## Application for Works Approval Amendment

### Part V Division 3 of the *Environmental Protection Act 1986*

<b>Works Approval Number</b>	W6283/2019/1
<b>Works Approval Holder</b>	Talison Lithium Australia Pty Ltd
<b>ACN</b>	139 401 308
<b>File Number</b>	DER2019/000216
<b>Premises</b>	Talison Lithium Mine Maranup Ford Road, GREENBUSHES WA 6254 Legal description – Mining tenements M01/3, M01/6, M01/7, M01/8, M01/9, M01/16 General purpose leases G01/1, G01/4 As defined by the Premises map attached to Schedule 1 of the Revised Works Approval
<b>Date of Report</b>	21 December 2022
<b>Decision</b>	Revised works approval granted

**Figure 1: Approved and proposed location for construction of CGP3**

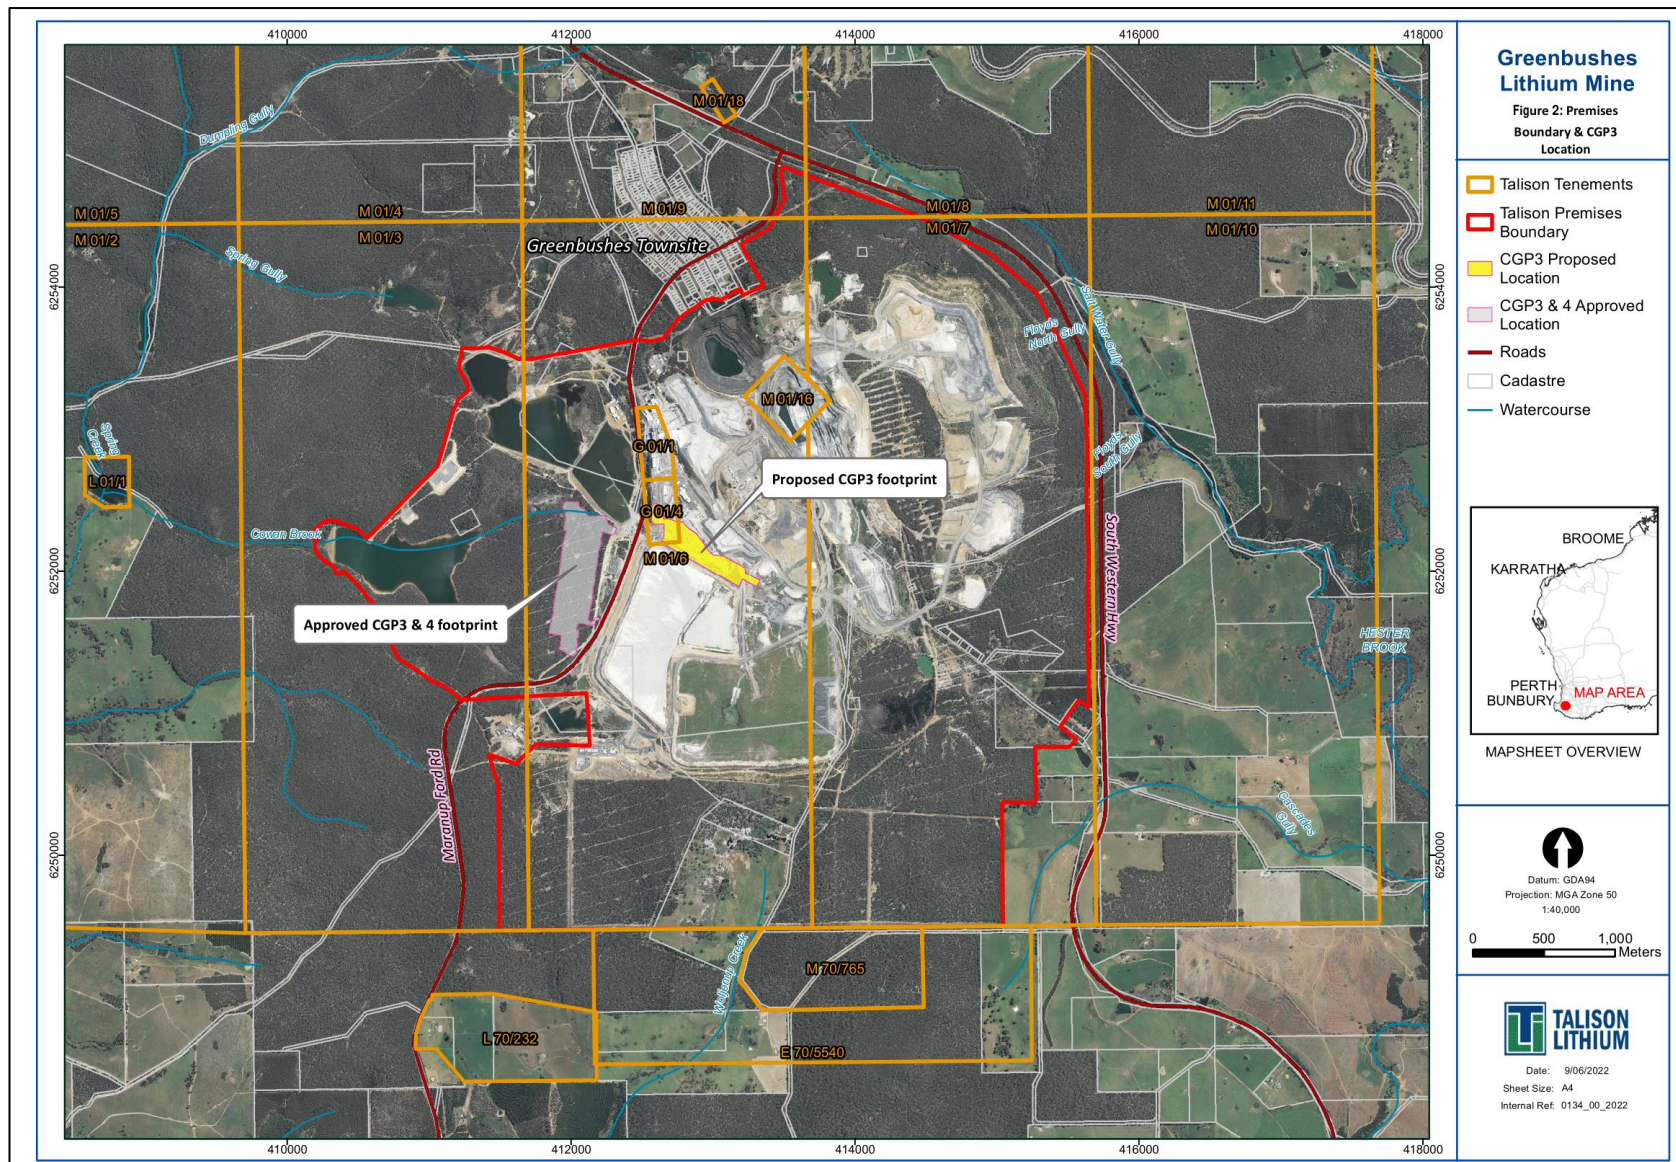
The Works Approval Holder has identified an opportunity to relocate CGP3 to the east side of Maranup Ford Road, adjacent to the operational CGP2, approximately 400 m from the current approved location (Figure 1). The primary purpose of the relocation was to avoid clearing vegetation by utilising land that had already been previously cleared.

As a result of the relocation, the extent of earthworks required during the construction of the infrastructure will be reduced, as the proposed location has already been cleared, as well as the smaller infrastructure footprint due to sharing of ancillary infrastructure with CGP2.

Further, the proposed overland conveyor crossing Maranup Ford Road would no longer be required to transfer crushed ore from Crusher 3 to CGP3. Nevertheless, CGP4 is currently in design phase with no plans to deviate from its approved location (Figure 1). Therefore, an overland conveyor will still be required to transfer ore to CGP4 once operational, noting that the amount of ore transferred will be reduced as the conveyed ore quantities will not be required to service CGP3 due to the relocation. An additional crusher (i.e., Crusher 4) will also be required to service CGP4 which has yet to be assessed by the department and is not authorised for construction in works approval W6283/2019/1. Any potential changes to CGP4 and the addition of Crusher 4 will be addressed in a separate amendment in the future.

**Figure 8: Noise bund design proposed in the (a) initial acoustic assessment and (b) updated acoustic assessment**

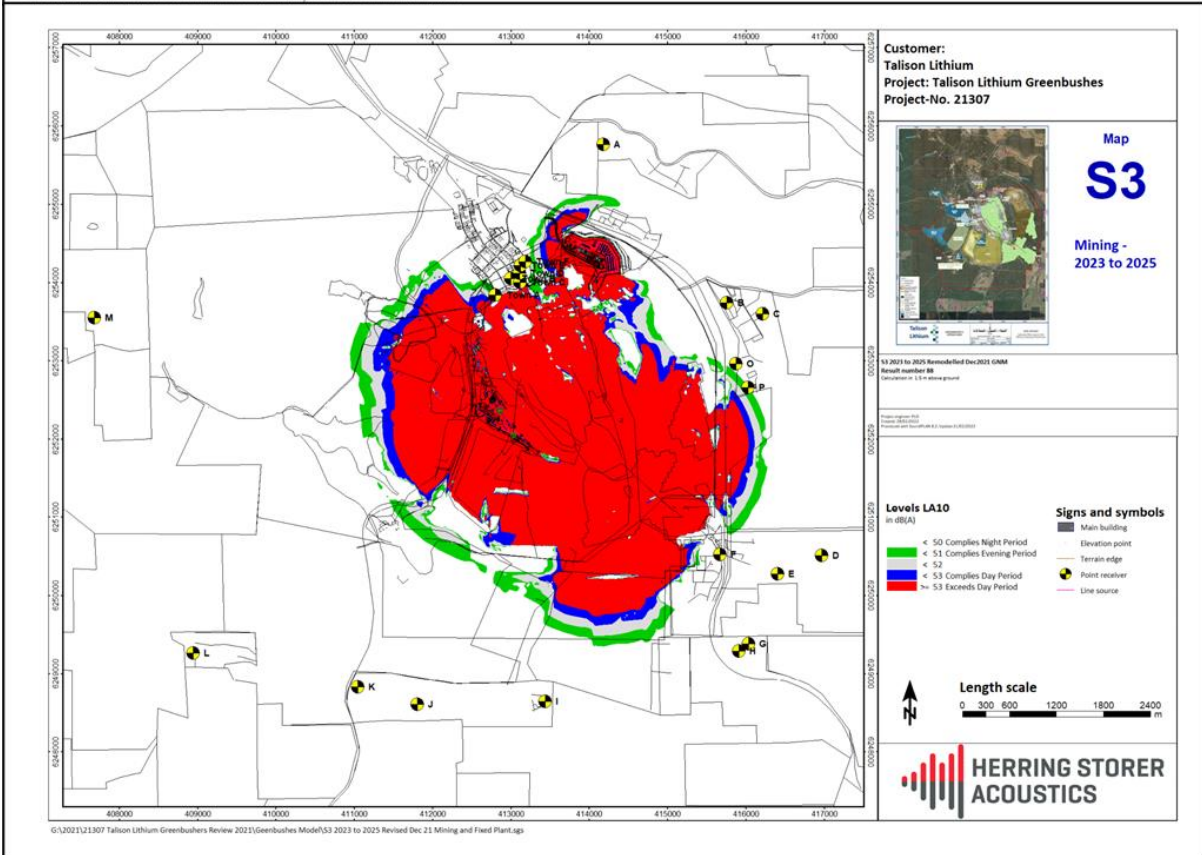
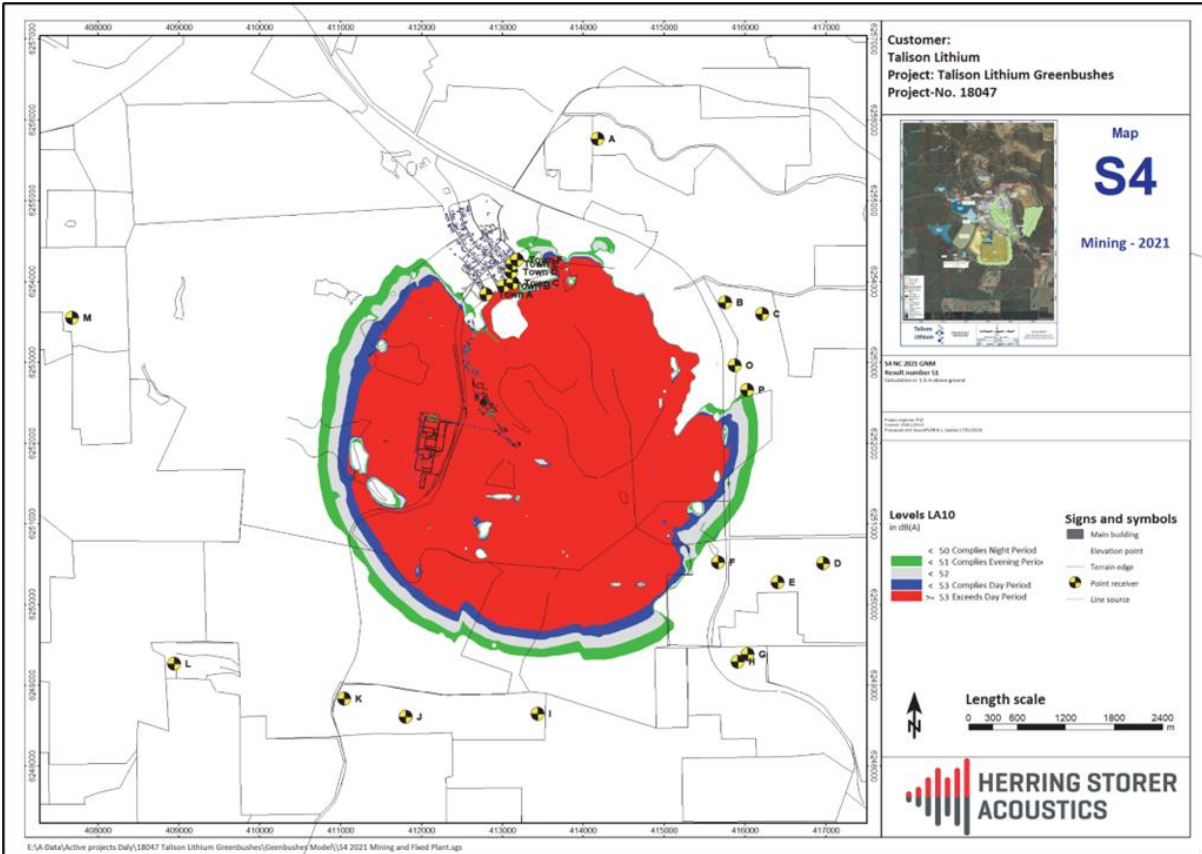
The updated acoustic assessment also altered the proposed controls for managing noise emissions, namely the design of the proposed noise bunds. Controls proposed in the initial acoustic assessment, which included the operation of CGP4, comprised two noise bunds (i.e., new bund at the northern end of the existing ROM pad and eastern extension of the existing noise bund) (Herring Storer Acoustics 2019) (Figure 8).

In the updated assessment, only an extension to the west of the existing bund was proposed (Figure 8). Although the predicted noise emission levels will still comply with the approved noise levels in the Greenbushes township, comparison of the noise contours between initial and updated assessment indicated that noise emission levels with the proposed bund design will result in a slight increase to noise emission levels in the township (Figure 7). Based on the noise level contours, the increase most likely attributed to the change in bund design, rather than the relocation of CGP3.

Approval granted under Regulation 17 of the *Environmental Protection (Noise) Regulations 1997* is based on what is practicably achievable in terms of noise reduction at the time of the application. Condition 7(1) of the *Environmental Protection (Talisson Lithium Australia Greenbushes Operation Noise Emissions) Approval 2015* states that the Works Approval Holder 'is to take all reasonable measures to reduce noise emissions from the mine site'. As such, the change in noise bund design in the updated acoustic assessment (which would lead to slightly higher noise emission levels compared to the initial design) would not typically be supported, unless the approval holder can demonstrate that the previous noise bund designs are not practicable or reasonable.

In a letter to the department dated 24 November 2022, the Works Approval Holder provided the following justification for the change in noise bund design:

- The revised design has a smaller footprint and requires fewer construction material quantities. As such, less clearing would be required, with reduced emissions and impacts related to the construction works (i.e., dust, noise, traffic);
- The Works Approval Holder do not possess sufficient quantities of geotechnically and geochemically suitable waste rock for the construction of the initial bund design within the relevant timeframes (i.e., prior to the operation of CGP3);
- The initial bund designs would excessively restrict access to the north-east of the premises, which may be required in the present and/or future; and
- Noise modelling undertaken as part of this updated acoustic assessment indicated that the revised noise bund design would still be adequate for complying with the approved noise emission levels.

Unlike the initial acoustic assessment, the modelling scenarios of the updated acoustic assessment does not include the operation of CGP4. As such, the updated noise bund may not be adequate to manage noise emissions from cumulative premises operations in the future, when CGP4 is operational. Another acoustic assessment will need to be undertaken in the future, prior to the operation of CGP4. The outcomes of the acoustic assessment may necessitate further modifications to the existing noise bunds or the construction of new noise bunds.

- The consequence rating was classed as **moderate**, as the proposed controls (including the revised noise bund design) would mitigate noise emissions during operations to an extent. However, it was noted that the noise bund was designed primarily for the township. Rural residential receptors surrounding the premises may be impacted to a greater extent;
- The likelihood rating was classed as **possible**, as noise emissions may vary depending on operational and meteorological conditions. Concerns from direct interest stakeholders and previous complaints were also considered in this assessment;
- Overall, the consequence and likelihood presented above have resulted in a **medium risk rating**.

The Delegated Officer considers the controls proposed by the Works Approval Holder to be adequate to manage noise emissions from the premises from impacting surrounding noise-sensitive receptors. The construction of the noise bund has been conditioned in the amendment works approval, in accordance with the Guideline: Risk Assessments (DWER 2020b).

**Figure 7: Modelled noise contours for the operation of CGP3<sup>1</sup> at the (S4) current and (S3) proposed locations**

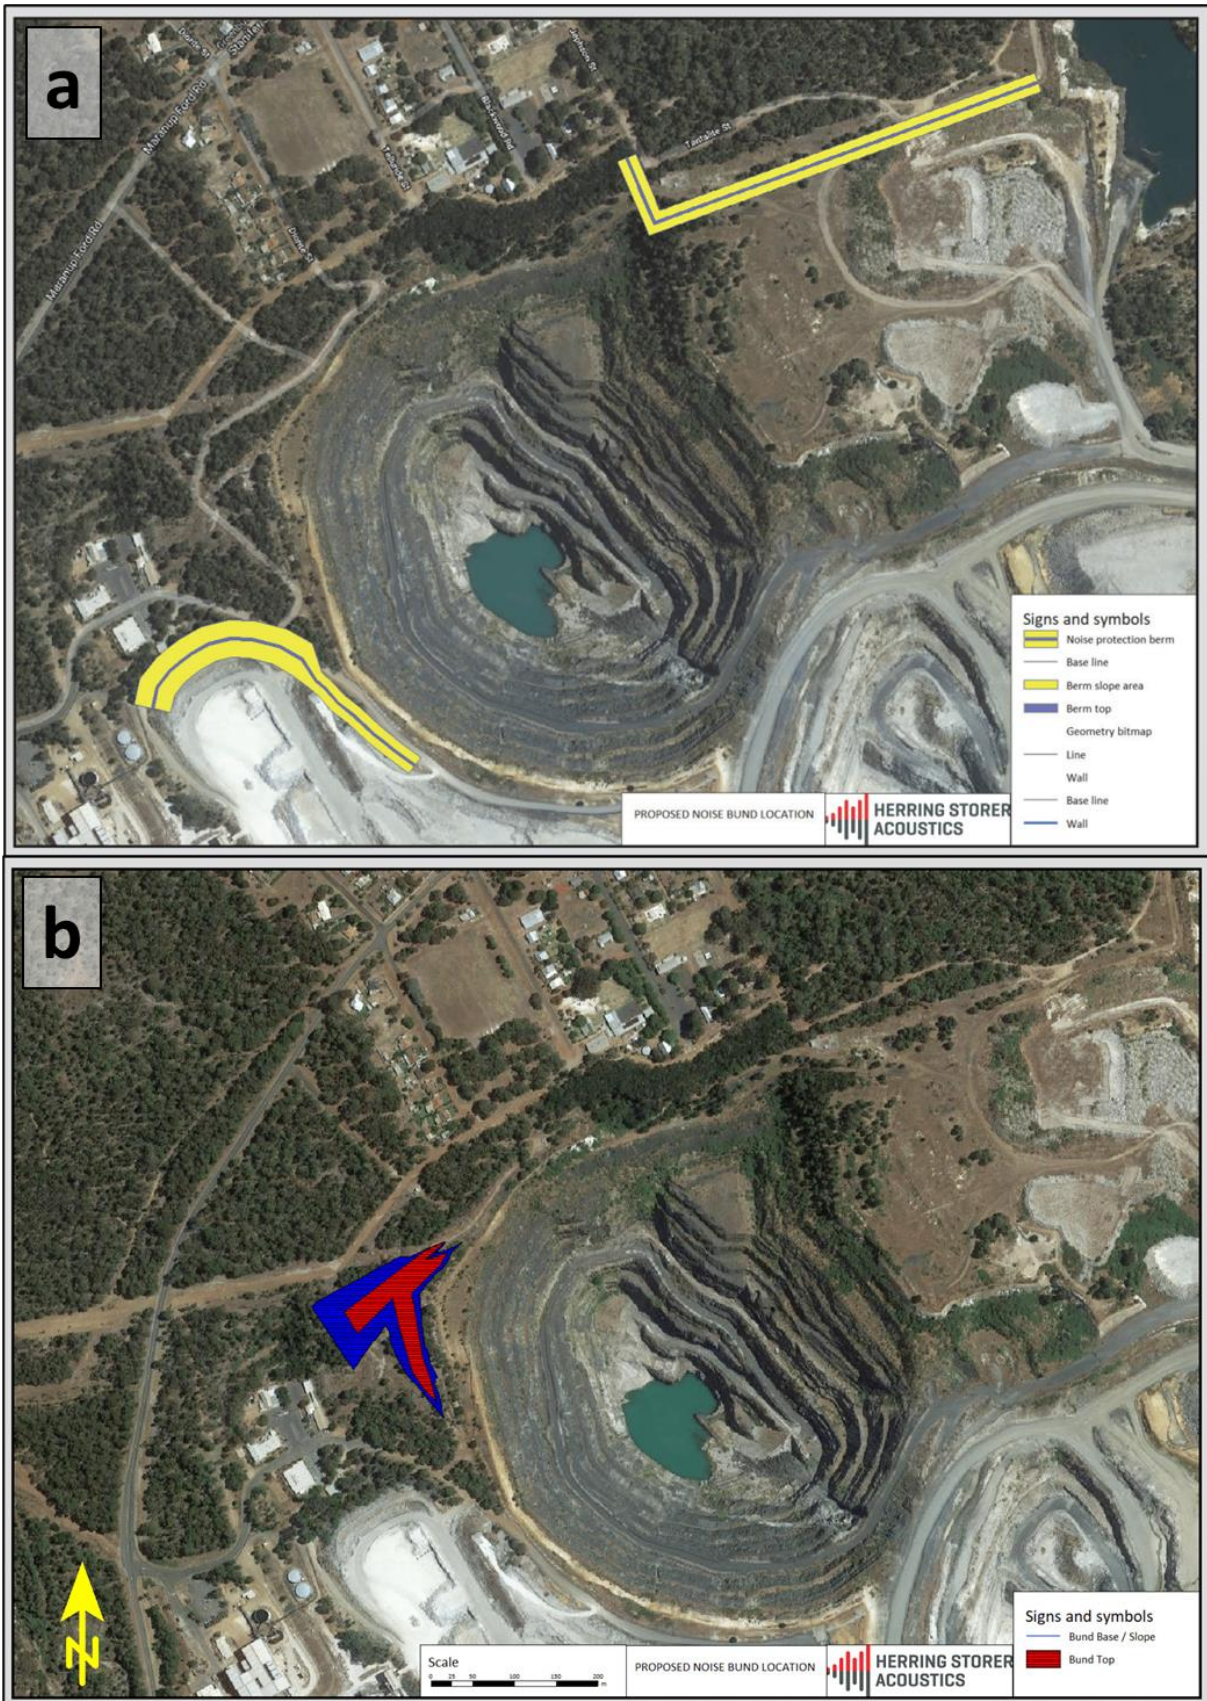
The relocation of CGP3 could potentially alter the extent and severity of noise emissions during operations on surrounding receptors. To better understand the risk profile, an updated acoustic assessment was undertaken (Herring Storer Acoustics 2022). The updated assessment included updated modelling scenarios, which comprised different mobile equipment configurations and excluded CGP4.

The assessment demonstrated that the operation of CGP3 at its proposed location would not result in a significant increase in noise emission impacts to the surrounding receptors, when compared to the current authorised location (Figure 7).
